Moss Beach Chevron
Highway access & landscape buffer
2011 - 2018

Midcoast Community Council
4/25/2018 presentation
by Lisa Ketcham

Summary MCC comments

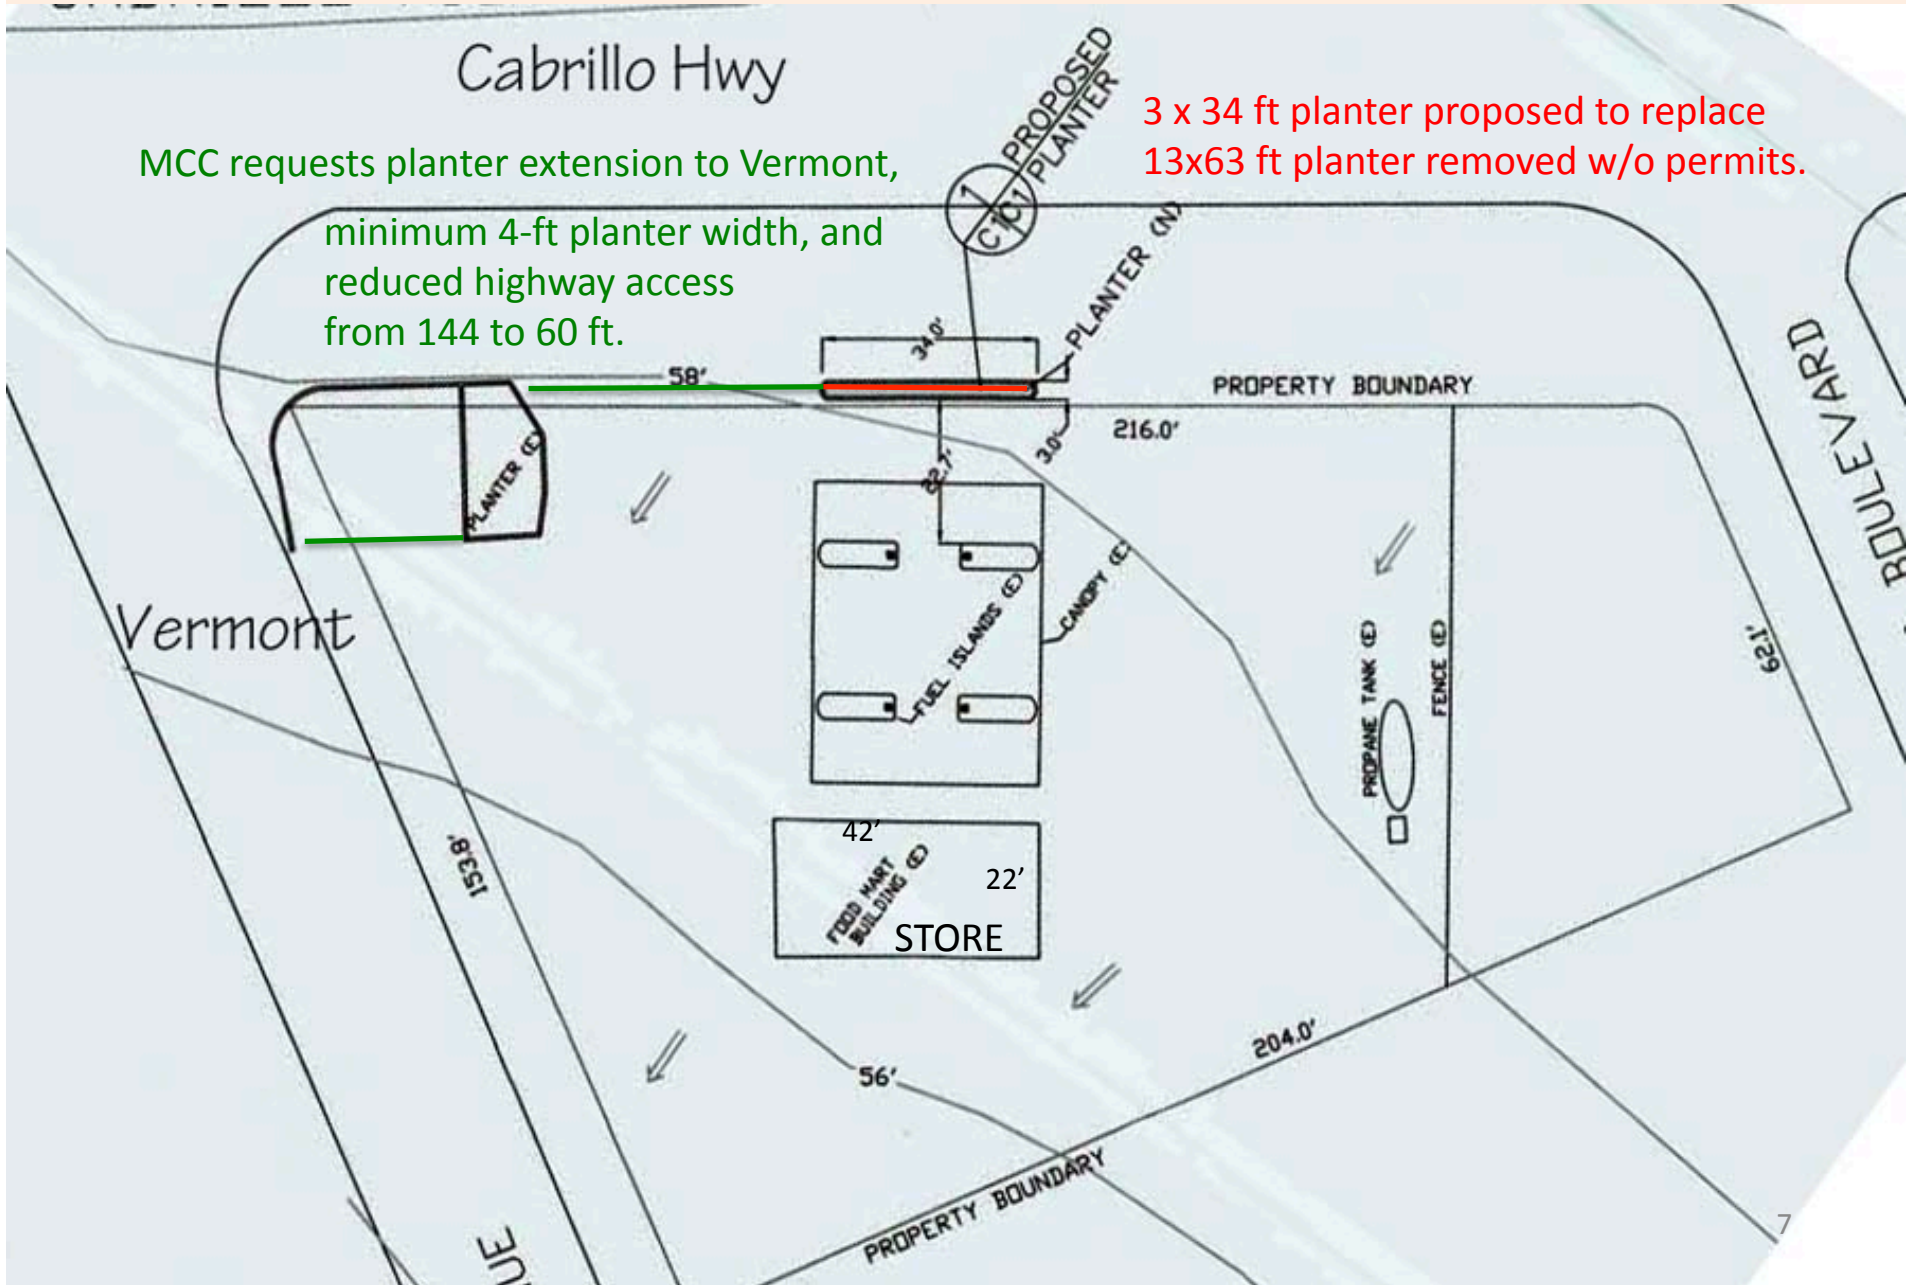
2017 Aug: CalFire comment: “The Fire District would prefer that the planter box not be added as part of the landscaping as it may be a possible traffic hazard during ingress and egress of the gas station.”

Reply: Planner will ask CalFire if there is an alternative based on MCC requests.
MCC request site visit to better understand emergency access requirements.

Moss Beach Chevron – 2017 site plan for planter construction

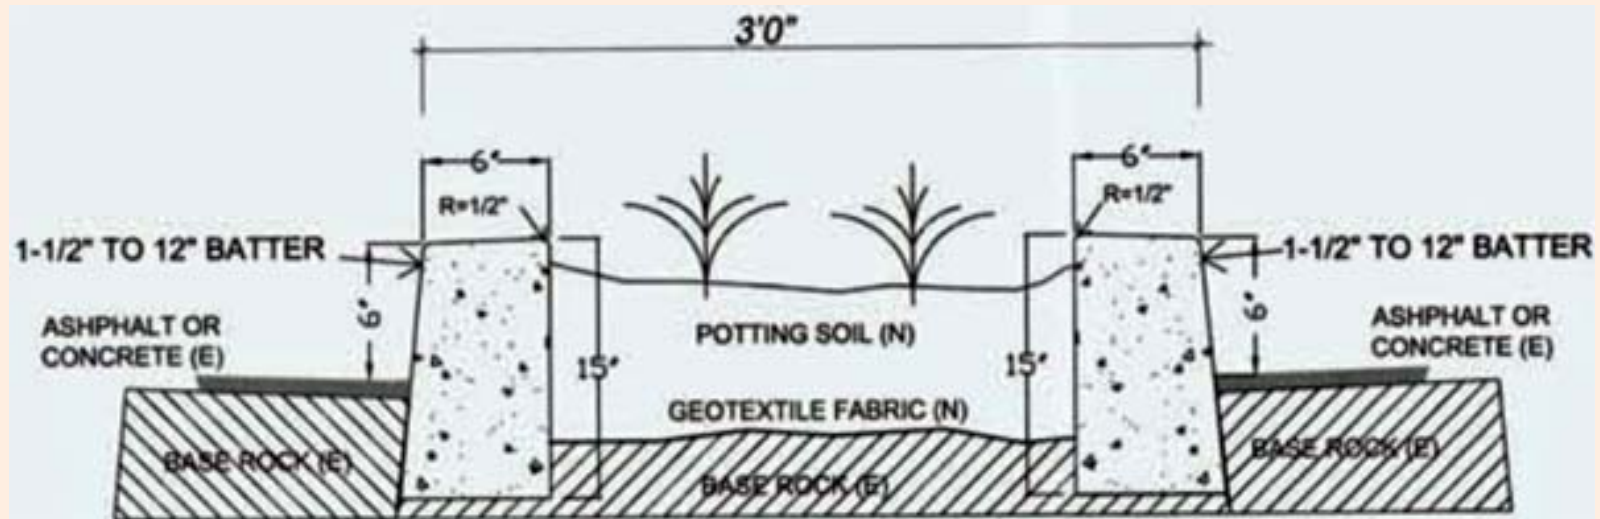
MCC requests planter extension to Vermont, minimum 4-ft planter width, and reduced highway access from 144 to 60 ft.

3 x 34 ft planter proposed to replace 13x63 ft planter removed w/o permits.

Proposed Curb Planter Detail Section 3 feet wide, 6 inches high

Curb (6" HxW) occupies one third of planter width.

Soil volume for plant growth:

- 2 ft wide, limited by concrete curb
- 1 ft deep, limited by geotextile fabric above base rock

No matter how drought tolerant, plant viability will be poor in this extremely limited soil volume.
